1968 Corvette: Service Bulletin: Refrigerant Leak

Model and Year: 1968 Vehicles with Air Conditioning **Source:** Chevrolet Dealer Service Technical Bulletin

Bulletin No: 68-T-56

Date: July 12, 1968

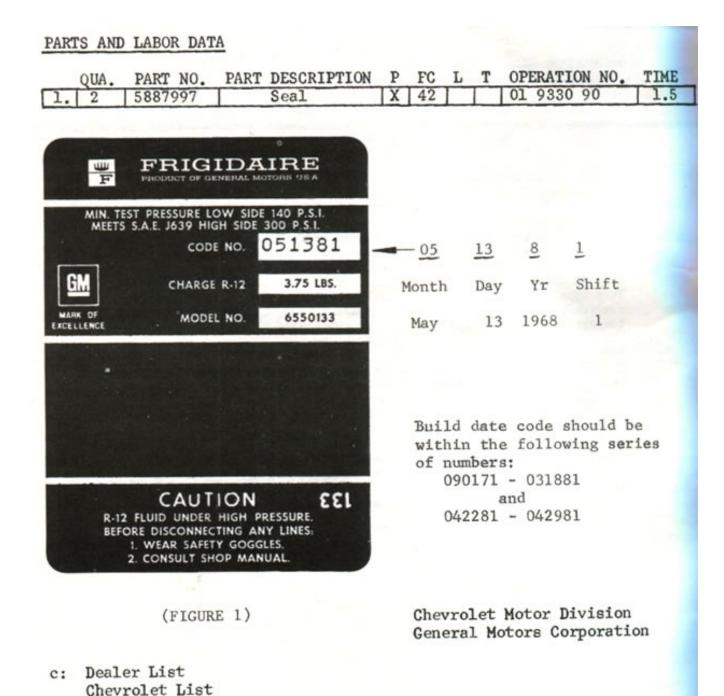
In production, the suspected seals were used between September 1, 1967 and March 18, 1968 and again between April 22, 1968 and April 29, 1968. Compressors built within these dates may be identified by noting the date stamped on the identification tag (See Fig. 1) located on top of the compressor.

For service, when a refrigerant leak is suspected but cannot be detected on compressors built within the above dates, the compressor suction and discharge seals located at the rear connector block of the compressor should be changed using the following procedure:

- 1. Discharge the system and remove the connector block from the rear of the compressor.
- 2. Remove two (2) O-rings from exposed cavities and discard.
- 3. Install new O-rings, Part No. 5887997, and reverse Steps 1 and 2.

Note: All new O-ring packages will be date stamped as of May 1, 1968. Any other O-ring should not be used. O-rings should be dipped in clean Frigidaire 525 viscosity refrigerant oil and immediately placed in suction-discharge port cavities. Do not drain or wipe excess oil from O-ring.

4. Add a dab of white paint after the shift digit on identification tag.
